Town of Kittery Maine Planning Board Meeting January 10, 2019

ITEM 3 - 88 Pepperrell Road – The Bistro – Parking Plan Review for Business Use Change

PARKING PLAN
PARKING LAYOUT
88 PEPPERRELL ROAD (ROUTE 103)
KITTERY POINT, MAINE

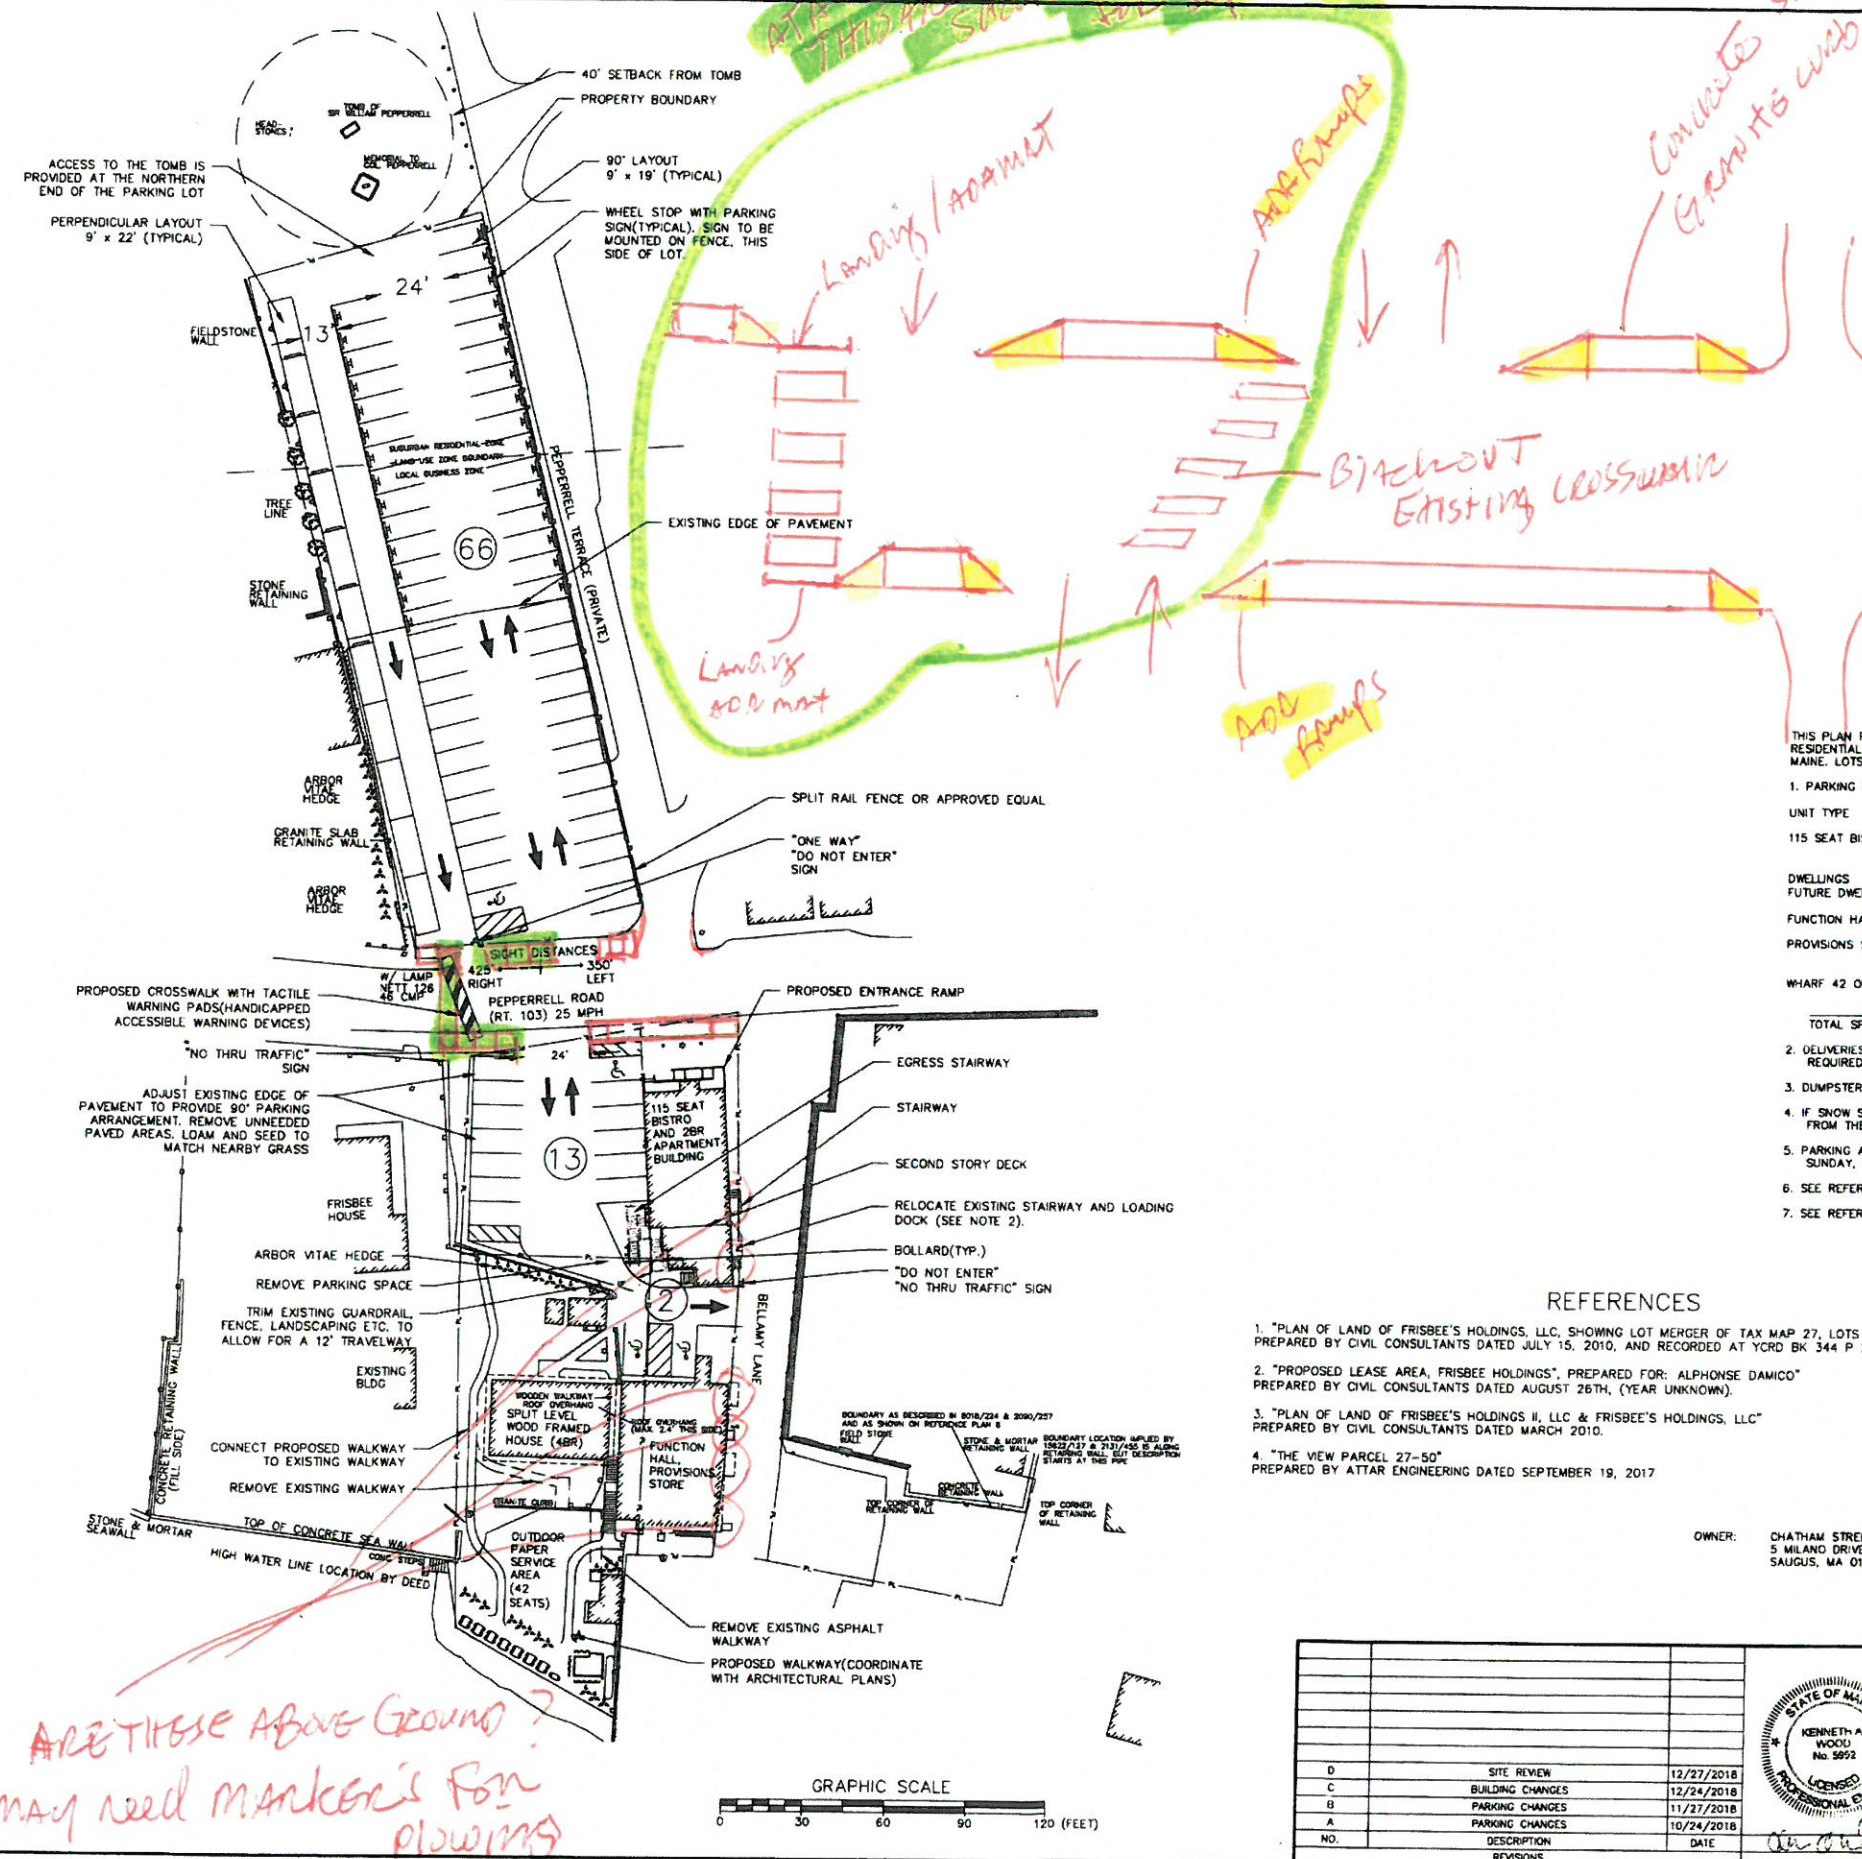
ARE THESE ABOVE GROUND?
MAY NEED MARKERS FOR PLOWING
TO SEE AT NIGHT.
